GRANT COUNTY DEPARTMENT OF PUBLIC WORKS

Re: 4-NE CRP 09-02 RAP Project #1307-01

ADDENDUM #1

4-NE Road, CRP 09-02 - Adjust Sewer Manholes

C-1

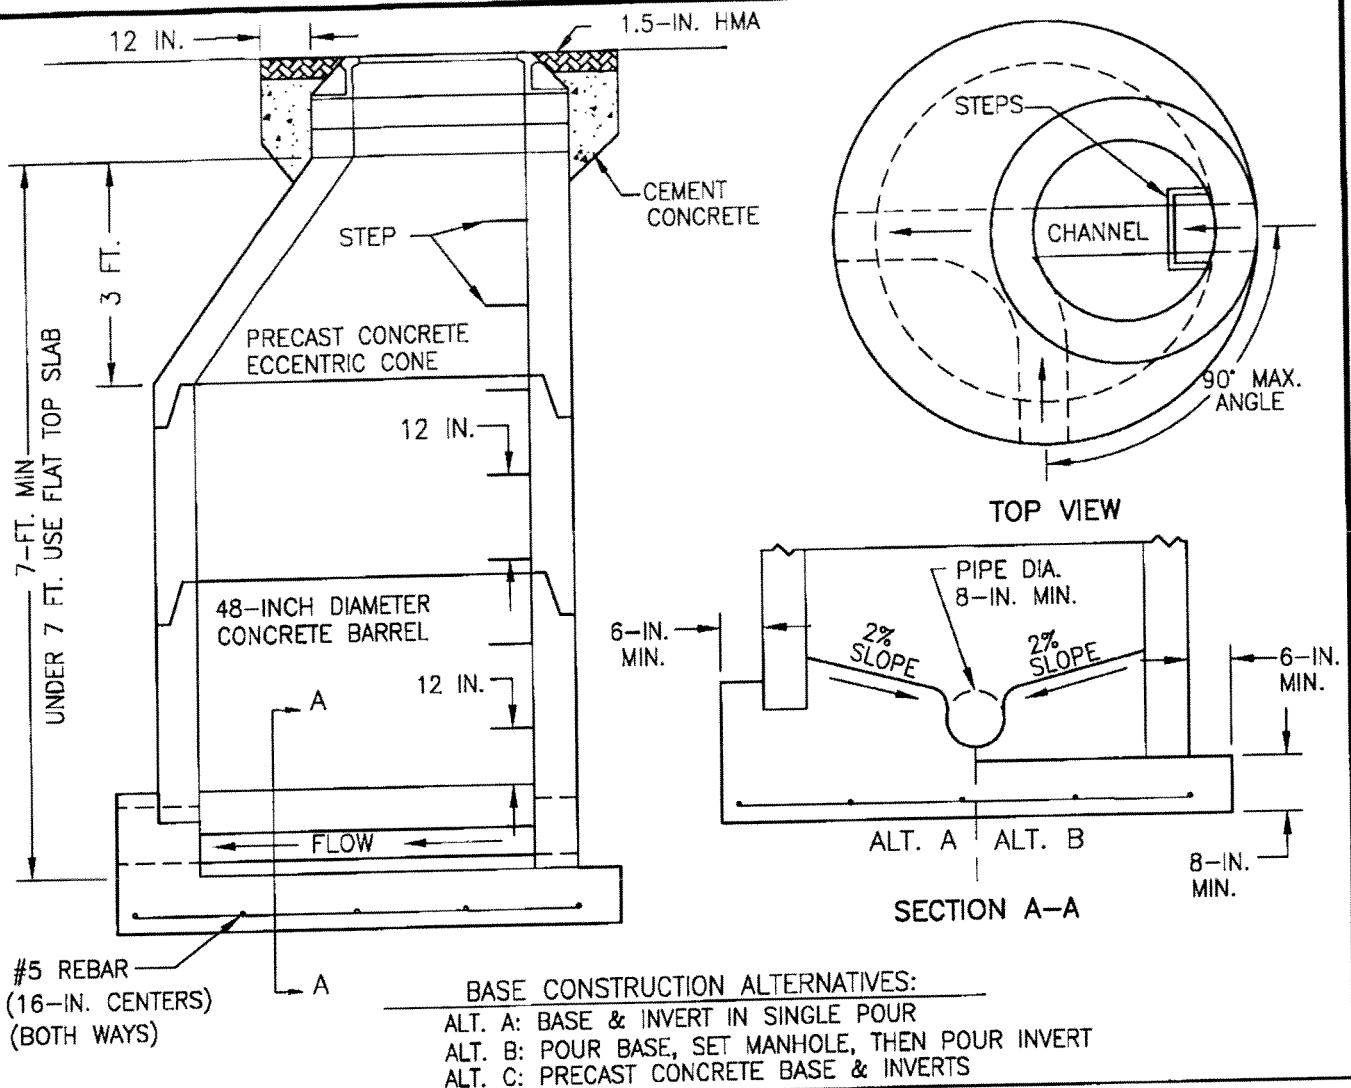
Manholes shall be adjusted per the attached table and The City of Moses Lake's Sewer Manhole Standard C-1. The table lists approximately the number of barrel sections and adjustment rings required. The unit contract price per each for "Adjust Sewer Manhole" shall be full pay for labor, equipment, materials and tools necessary to complete the Work as Specified.
